TSG-RAN Working Group 1 meeting #11
San Diego, CA, USA
February 29 – March 3, 2000

TSGR1#11(00)0239

Title: CR 25.211-028r1: Timing of PDSCH

Figure 28: Timing relation between DPCH frame and associated PDSCH frame

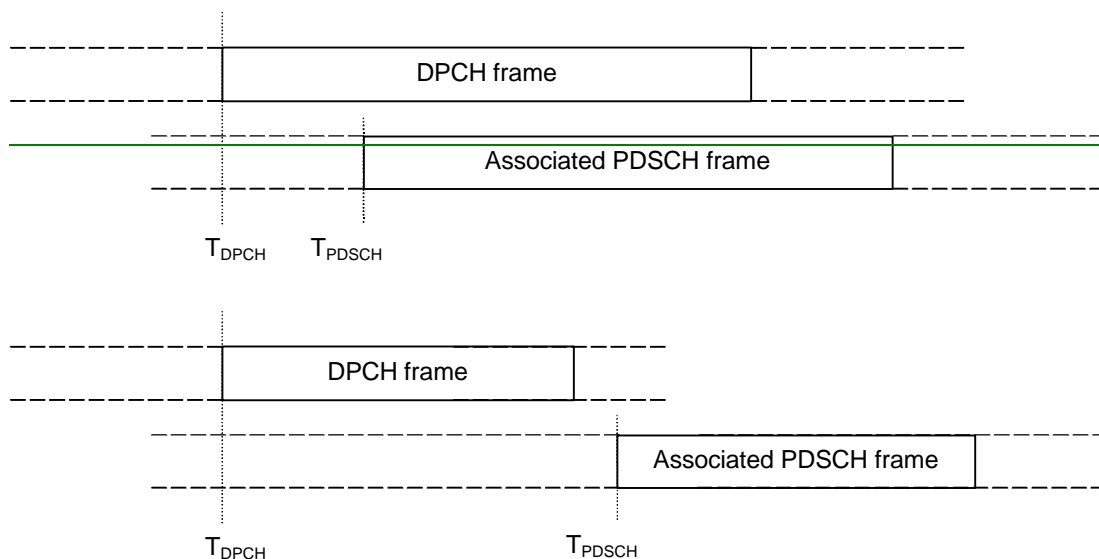
The start of a DPCH frame is denoted T_{DPCH} and the start of the associated PDSCH frame is denoted T_{PDSCH} . Any DPCH frame is associated to one PDSCH frame through the relation ~~$-35840 \text{ chips} < T_{DPCH} - T_{PDSCH} \leq 2560 \text{ chips}$~~ $46080 \text{ chips} \leq T_{PDSCH} - T_{DPCH} < 84480 \text{ chips}$, i.e. the associated PDSCH frame starts anywhere between three slot after the end of the DPCH frame ~~1 slot before or~~ up to 184 slots behind the end of the DPCH frame.
